Reply to Reviewers' comments (Reviewer#1)

Reviewer #1: This research provides a large ensemble of water balance ET estimations using existing global datasets. Sound comparisons with mainstream ET products have been reported. Uncertainty assessment is also performed on different scales. The manuscript is within the scope of ESSD journal. Minor revisions need to be considered before publication. Please find details below:

Figure 2: Flowchart and the characteristics of the data sets in the study. Please see the data section for detailed descriptions of the various datasets. Numbers in the parentheses denote the number of the particular datasets used in our study.

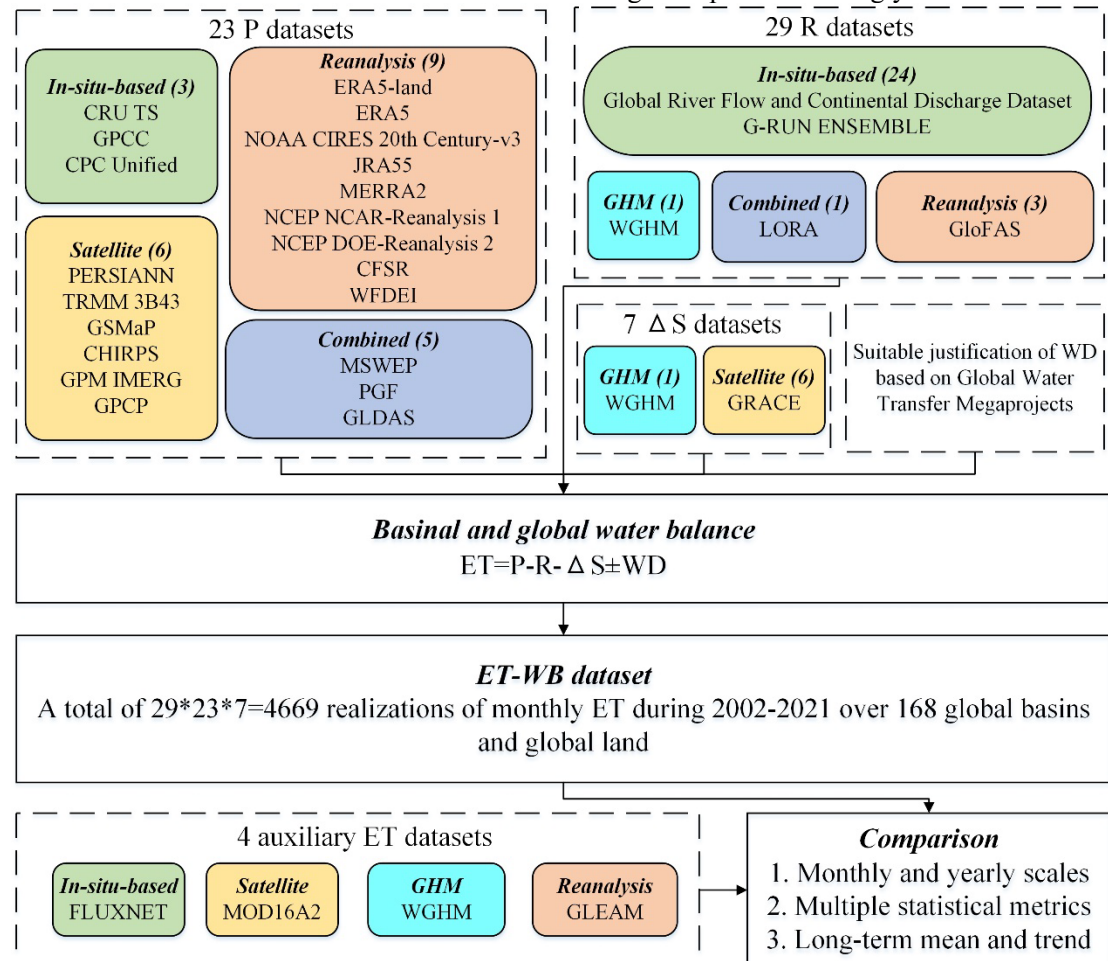
(6) You may indicate the explicit number of datasets used in your workflow in Fig.2.

Response: We have added the exact number of applied datasets adjacent to each variable in Fig.2 of the new version as below. We have also modified the figure caption accordingly.
